Groundwater Transfer Review Summary Form

Transfer/PA # T- 14813

Application: T-14813

Applicant Name: Kuenzi Turf and Nursery c/o Tyler Kuenzi

Map

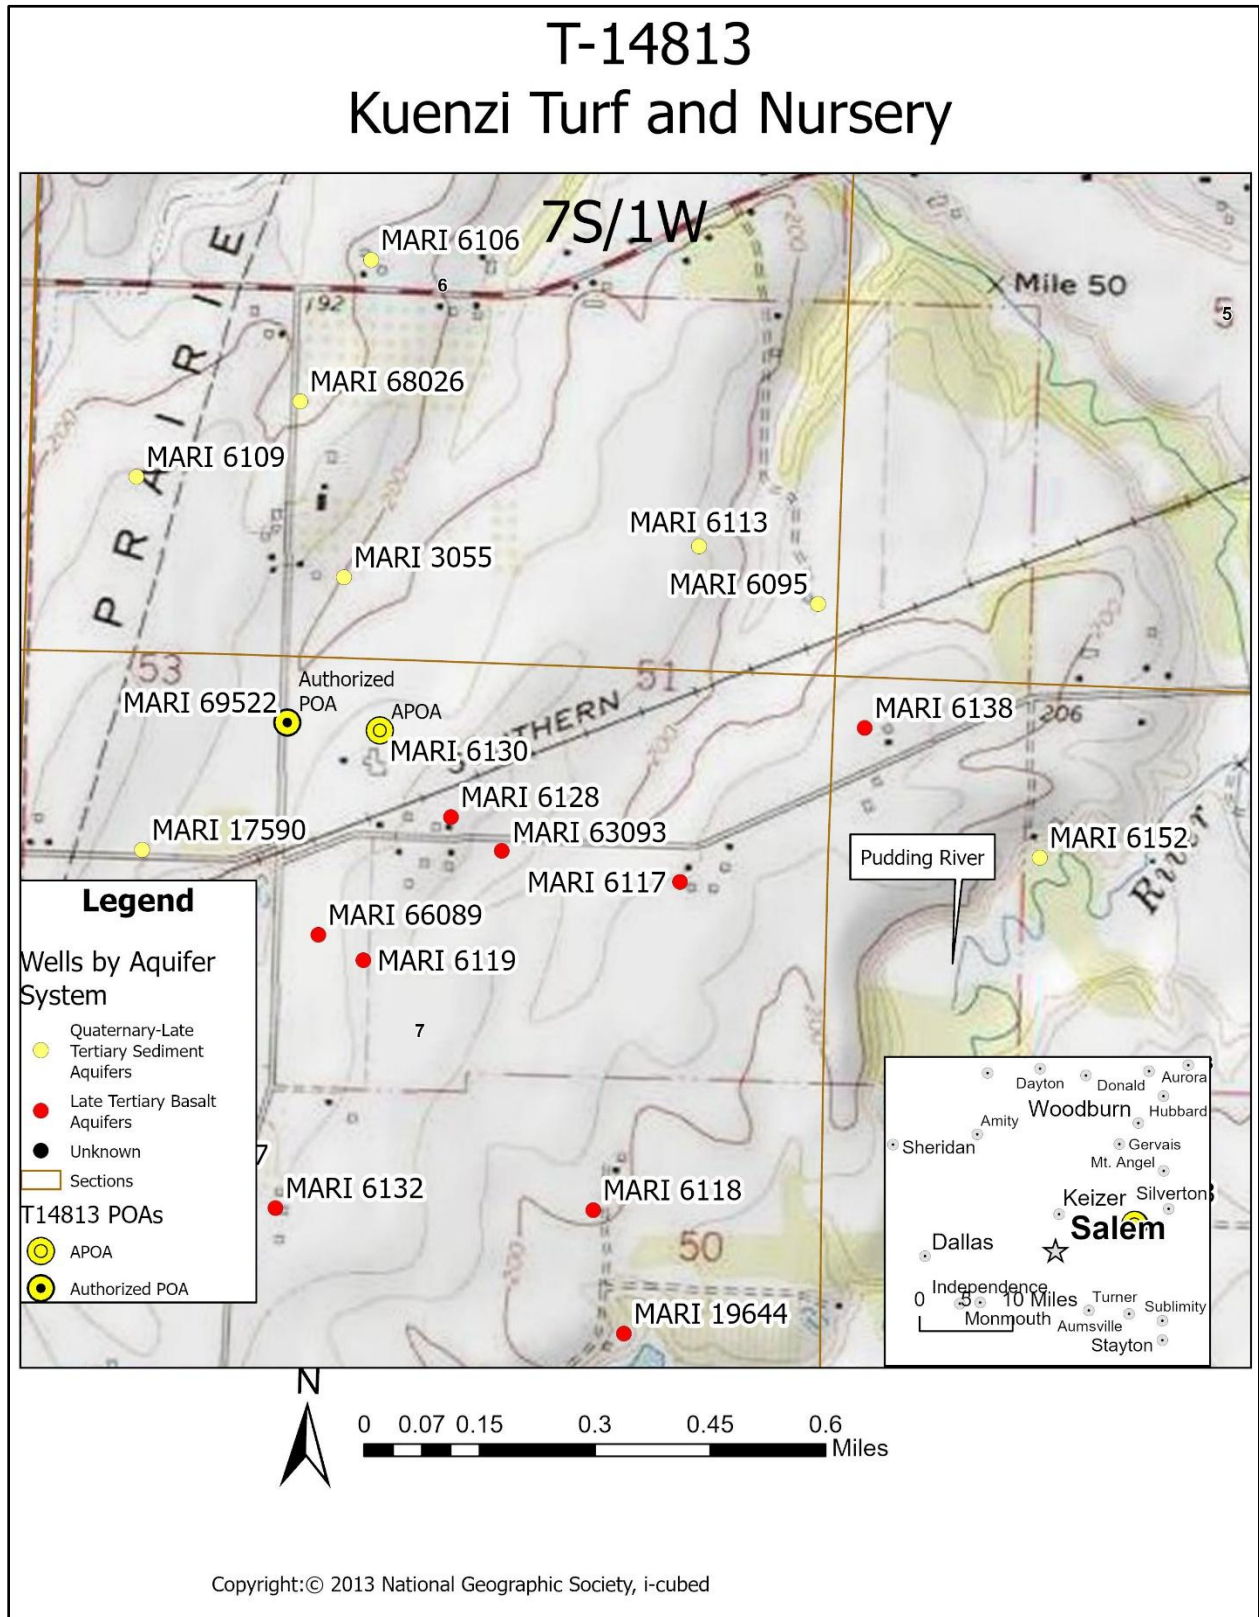
5. a) Will this proposed change, at its maximum allowed rate of use, likely result in an increase in interference with **another ground water right**?
 Yes No Comments: The proposed APOA, Well 3 (MARI 6130) is closer to MARI 6113/6112 than the authorized POA.

- b) If yes, would this proposed change, at its maximum allowed rate of use, likely result in another groundwater right not receiving the water to which it is legally entitled?
 Yes No If yes, explain: APOA, Well 3 (MARI 6130) is 2,529 ft southwest of MARI 6113/6112, a POA authorized under Certificate 28456. The Theis (1935) solution for drawdown was used to assess the potential for injury to MARI 6113/6112 from the proposed changes (see attached Theis Interference Analysis). Results indicate the proposed change is unlikely to result in MARI 6113/6112 not receiving the water to which it is legally entitled

6. a) Will this proposed change, at its maximum allowed rate of use, likely result in an increase in interference with **another surface water source**?
 Yes No Comments: The proposed APOA, Well 3 (MARI 6130) is closer to the Pudding River than the authorized POA

- Provide context for minimal/significant impact: Given the distance and the thickness of the overlying confining layer of clay, the increase in interference with the Pudding River is anticipated to be minimal.

Injury analysis

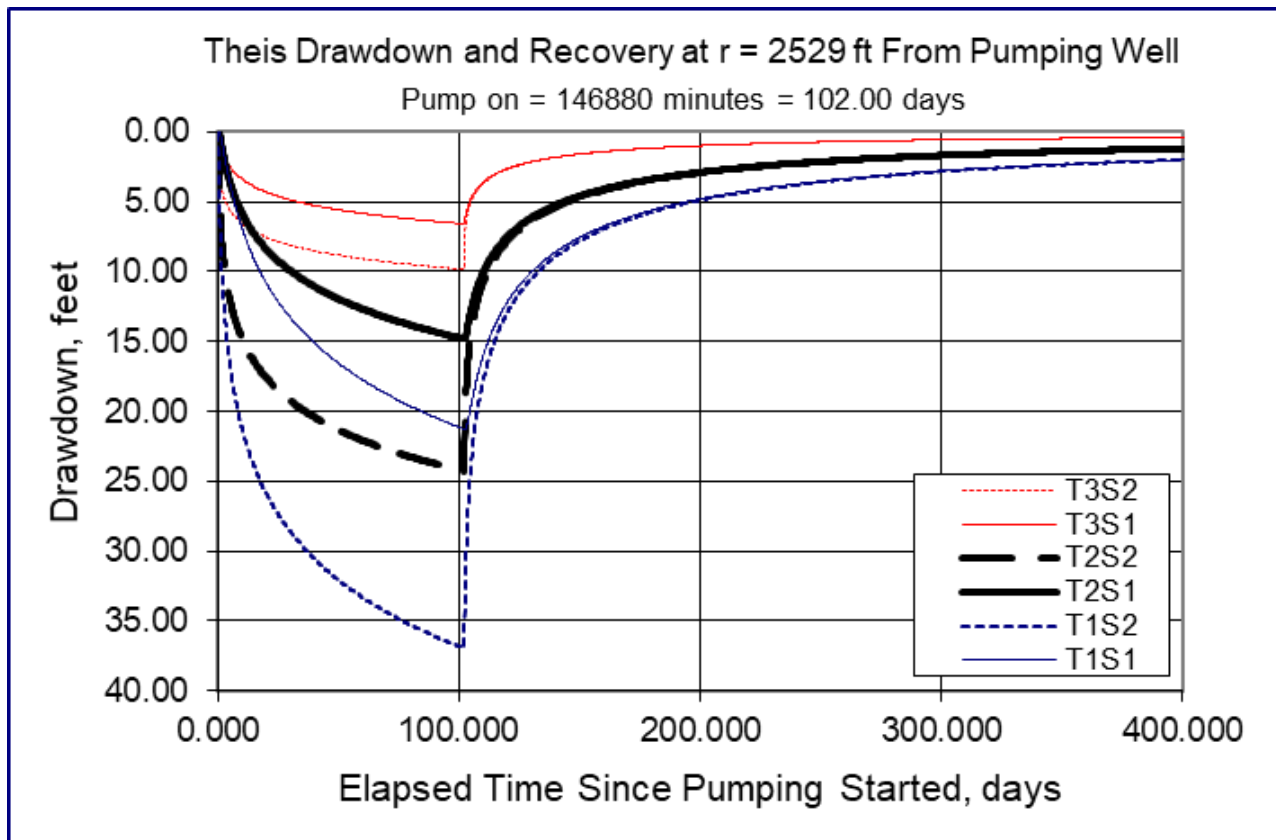
*The full, combined authorized rate of 0.6 cfs (369 gpm) could not be used for the entire irrigation season without exceeding the maximum, combined volume of 121 AF. At 0.6 cfs, the 121 AF combined volume would be used within 102 days. Furthermore, the applicant would be required to reduce the rate under the subject certificate during the month of September.

SWL	28 ft bls	MARI 6113/6112
<hr/>		
Aquifer Bottom	500 ft bls	Gannett & Caldwell 1998
Available Water Column	472 ft	Aquifer bottom-SWL
Pump Height Above Bottom	5 ft	Estimate
NPSHa	5 ft	Estimate
Drawdown	42 ft	MARI 6113/6112
<hr/>		
Minimum Water Column	52 ft	Estimated Drawdown + NPSHa + Pump Height
Injury	420 ft	Available Water Column-Minimum Water Column
